*Preliminary Consultation*  
**MONTGOMERY COUNTY HISTORIC PRESERVATION COMMISSION**  
**STAFF REPORT**

<b>Address:</b>	10115 Connecticut Ave., Kensington	<b>Meeting Date:</b>	4/28/2021
<b>Resource:</b>	Primary (Two) Resource <b>Kensington Historic District</b>	<b>Report Date:</b>	4/21/2021
<b>Applicant:</b>	Sina Sahand	<b>Public Notice:</b>	4/14/2021
<b>Review:</b>	Preliminary Consultation	<b>Staff:</b>	Dan Bruechert
<b>PROPOSAL:</b>	Building Addition and Modifications to the Existing Building

HP-1

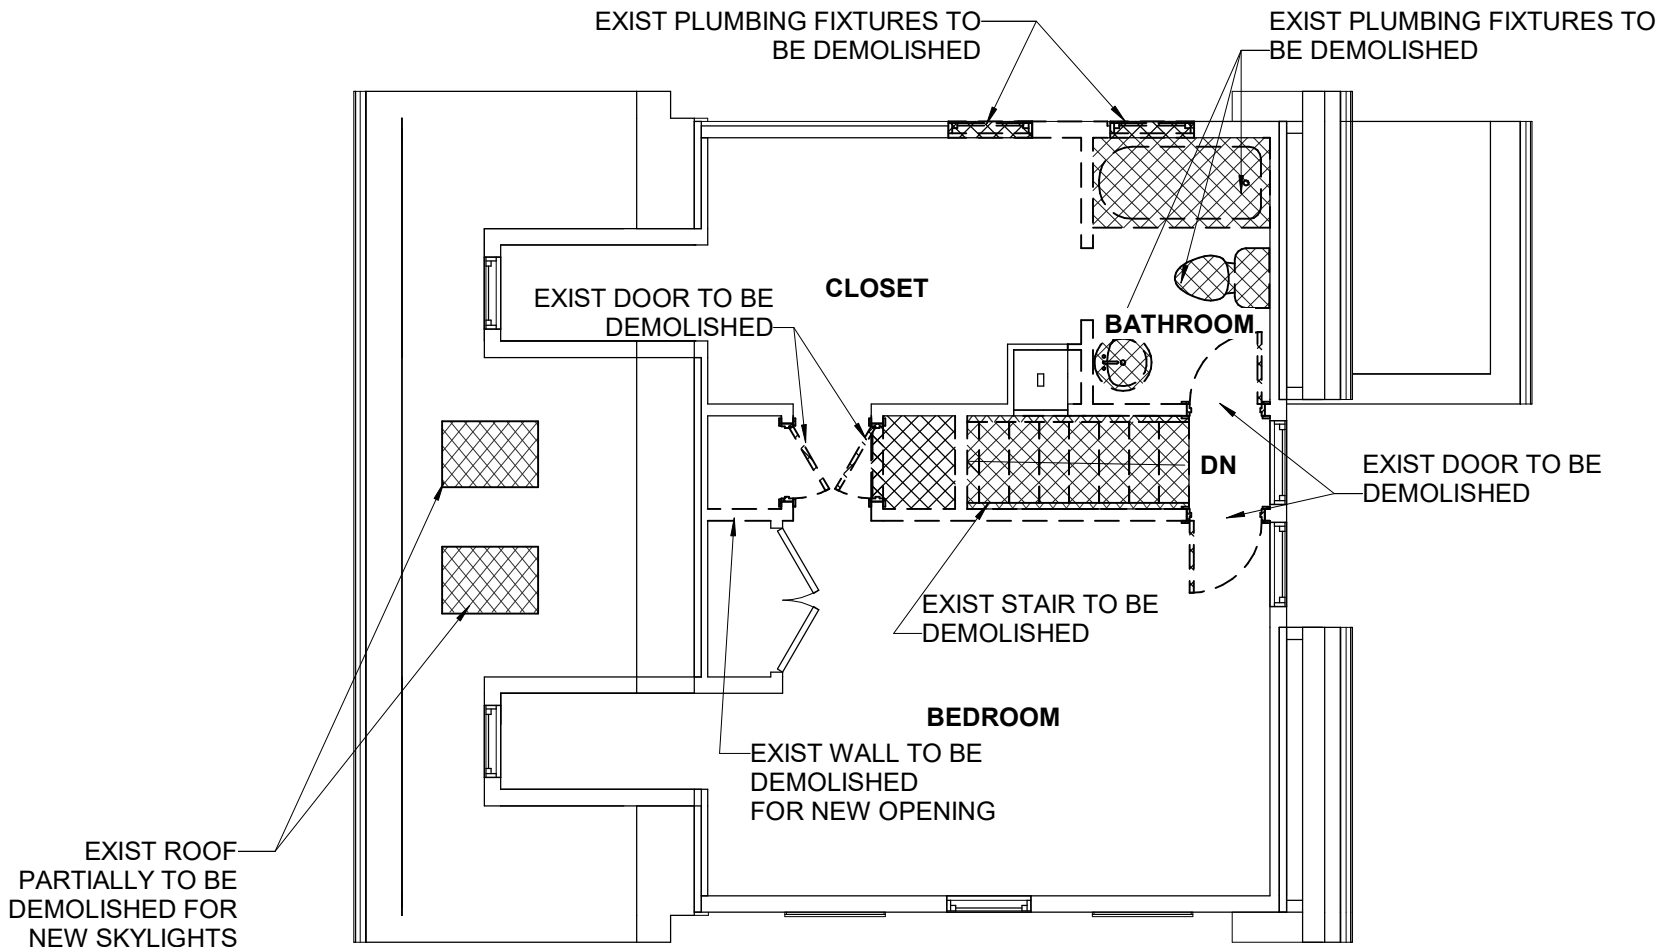
Staff notes that no site work was included in this proposal. There is a one-car parking pad in front of the house and Staff believes more on site parking may be required. The lot is very small and the applicant is limited in locations for additional parking. Staff recommends extending the existing driveway towards the rear of the lot or widening the existing parking pad to the south. There are utilities in this area as well, so this may require a subsequent HAWP at a later date after further study.

HP-8

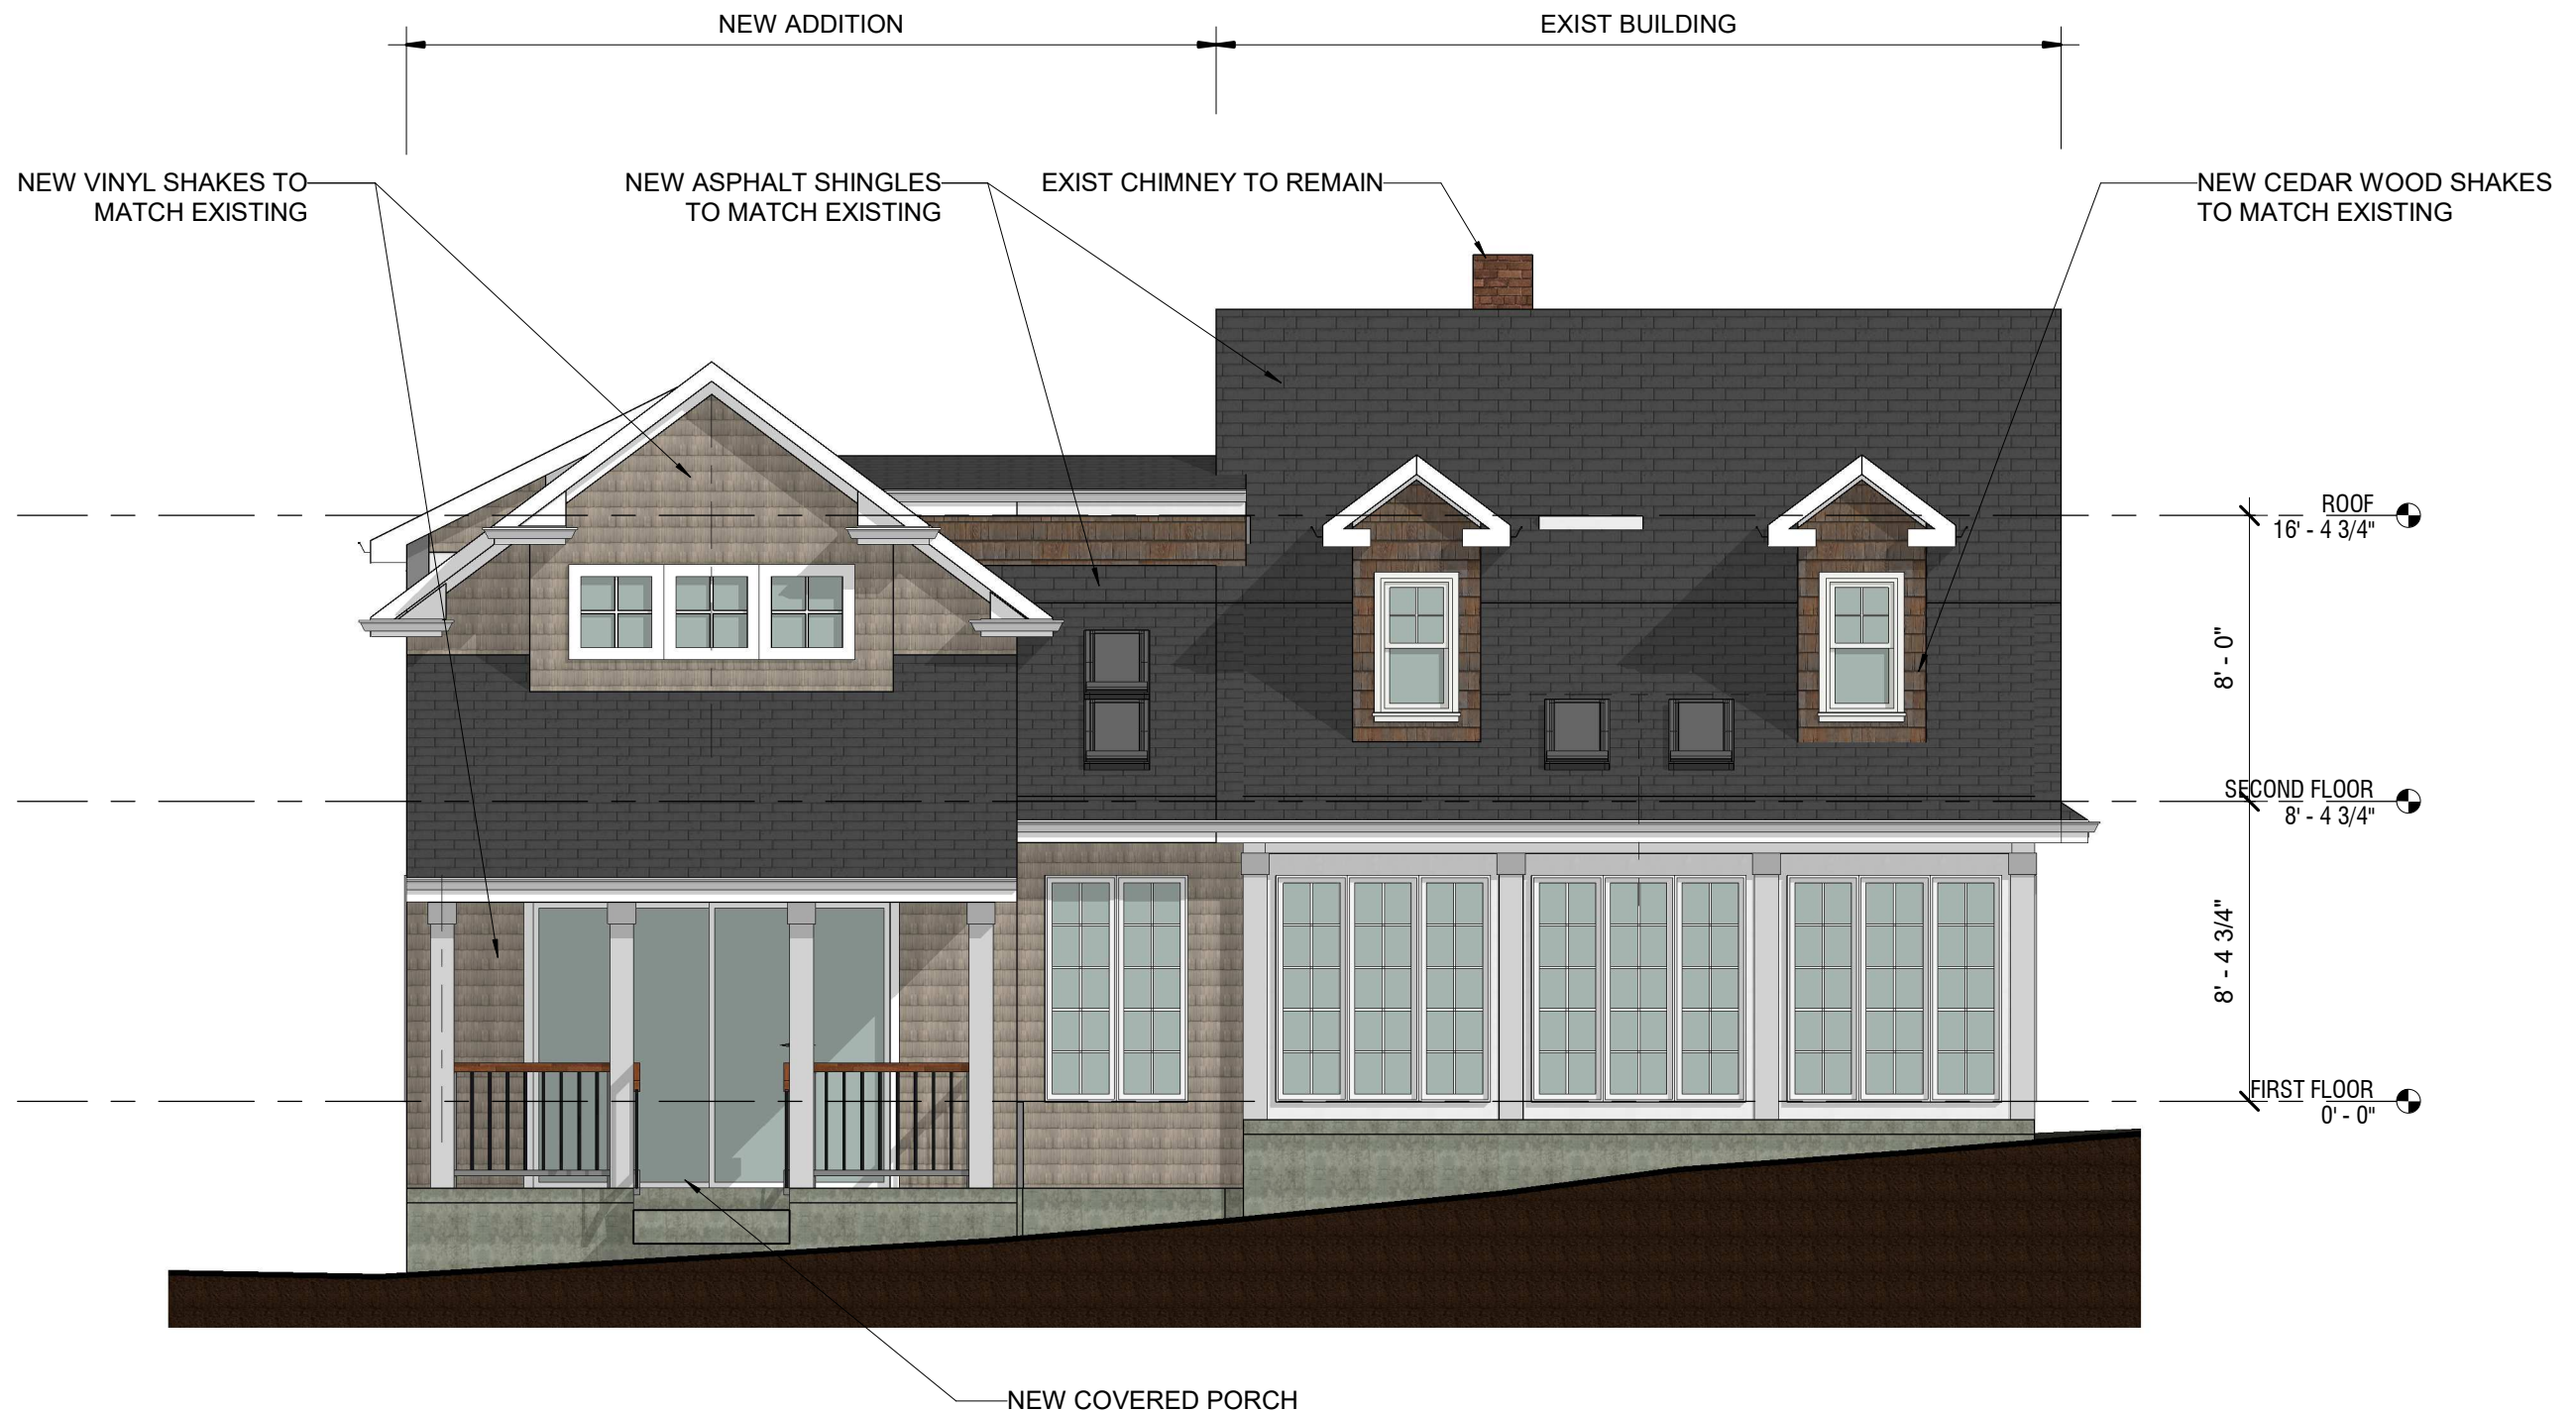
The addition has a side gable roof with a small shed dormer facing east. The gable ridge is below the existing, historic ridge height. The north side of the addition has a covered front porch on the ground floor with a triple set of casement windows above. The porch roof slope matches the house roof. On the east side of the house, there is a set of casement windows on the first floor and a pair of sash windows on the second floor. On the first floor of the south elevation, the secondary entrance will be reconfigured and there is a triple set of casement windows. On the second floor, there is a small projecting bay with three sash windows.

Staff finds that two areas of the design need to be revised to be compatible. First, the projecting porch should either be reduced in size or moved to the western side of the addition. This would reduce the visible mass of the addition. It appears to Staff that the porch reorientation could be accomplished without significantly reconfiguring the interior. Second, Staff finds that some of the eave returns on the addition should be eliminated to help make the addition appear subservient to the simply detailed historic construction.

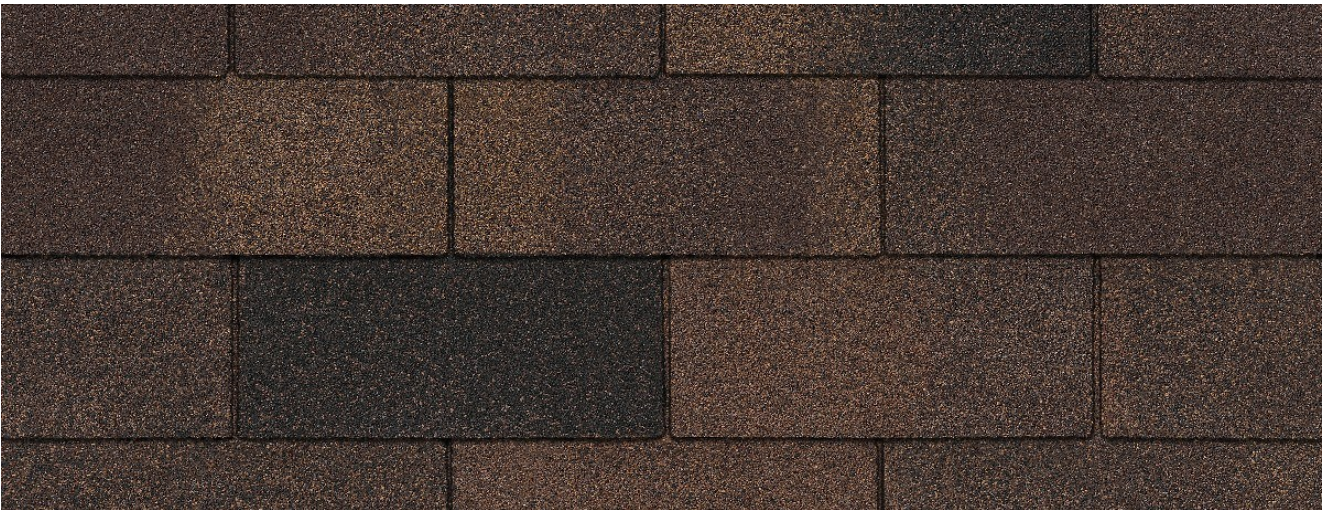
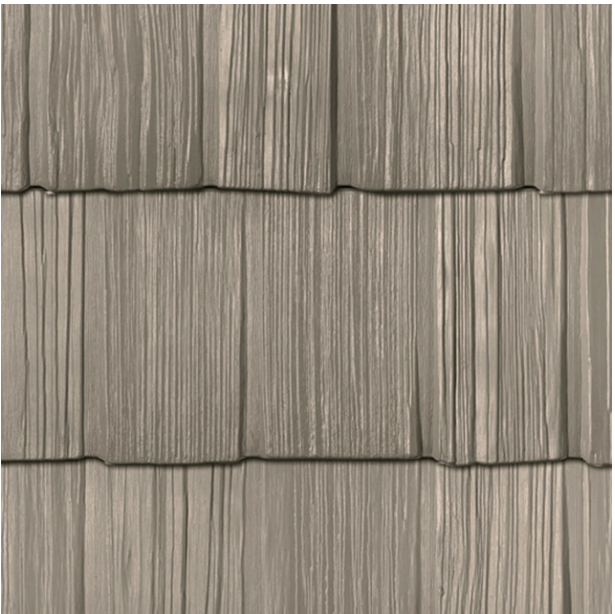
The last change proposed for the existing house is to remove the rotten cedar shake siding and replace it with vinyl shakes (Foundry, staggered shake). The cedar does appear to be suffering from deferred maintenance and is rotting in locations. Staff finds that removing the cedar piecemeal is not an effective strategy and would recommend the HPC approve its removal as a HAWP. Staff does not find the proposed vinyl to be an appropriate substitute material. Staff finds the proposed vinyl has a very flat profile that is inconsistent with the much thicker cedar. Additionally, cedar ages and develops a patina, and the vinyl siding has a slightly shiny appearance that will not diminish over time. Staff recommends the HPC require either a replacement cedar shake or a different wood siding for the historic portion of the house. A clapboard or shiplap siding would be compatible both with this house and the District.

Materials for the addition include vinyl shake siding (Foundry, Staggered Shake) and Pella Architect Series windows and doors, Pella's aluminum-clad wood line. The roof will be covered in a three-tab shingle to match the historic house. Staff finds the proposed doors, windows, and roofing to be compatible with the historic house and would recommend approval as a HAWP. Staff finds the siding, however, is not appropriate for the reasons cited above. As this is new construction, there are a variety of materials that may be appropriate. Standard 9 requires new construction to be differentiated from the historic. Staff finds the proposed addition is already sufficiently differentiated by its form and window configuration that the siding could match the historic and the proposal would still comply with the Standard. Staff recommends either a natural wood siding or fiber cement clapboard be used for siding on the new construction.
